# VALUE ENGINEERING WORKSHOP

## WIDENING SR17 – IMPROVEMENTS PROJECT EDS 545 (43) Warren & McDuffie Counties, Georgia

24 August 2006

**SUMMARY OF RECOMMENDATIONS  
EDS 545(43) SR – 17 IMPROVEMENTS  
24 AUGUST 2006**

# PROPOSED CHANGE SKETCH/DETAIL

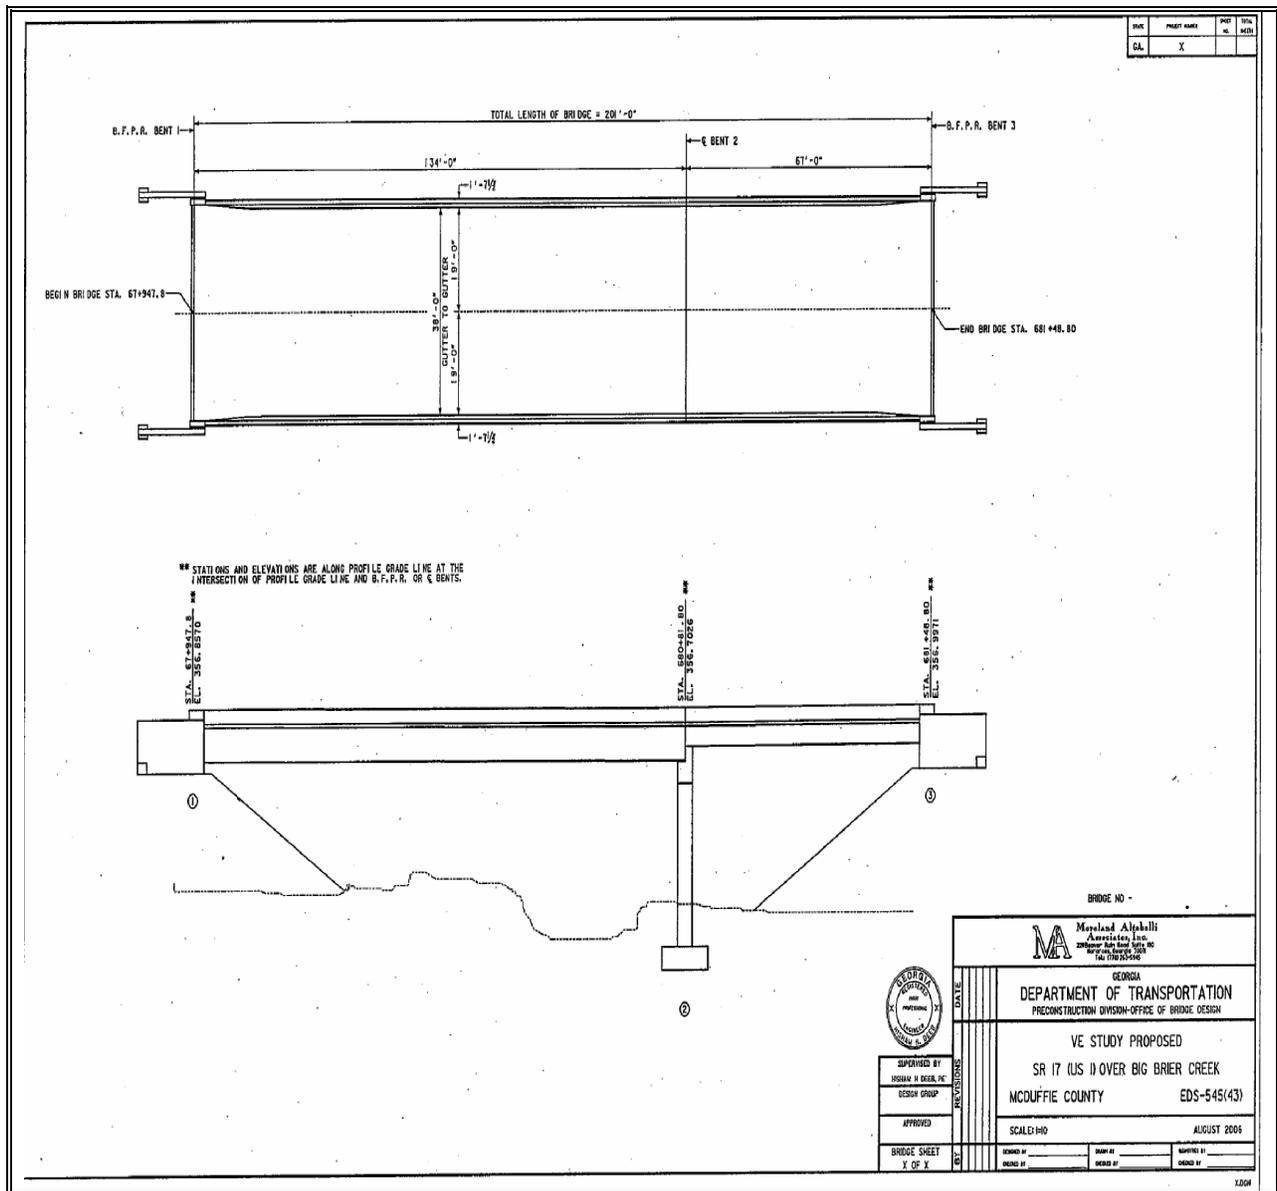
<b>ORIGINAL DESIGN:</b>	The original design proposes the same span arrangements as the existing bridge over Big Brier Creek (67'-0" spans EA.) with Type III beam superstructure and two intermediate RC column bents.
<b>PROPOSED CHANGE:</b>	The proposed design intends to optimize the design by utilizing 2-spans Type III (67'-0") & BT 72in (134'-0") in lieu of 3-spans Type III (67'-0" EA.). The design will enhance the hydraulic opening by eliminating an intermediate pier and cofferdam which would expedite the construction process as well as reduce cost. Since the difference in elevations between the floodstage and the beam bottom chord is generous a BT beam can be accommodated and not in opposition to the guidelines.
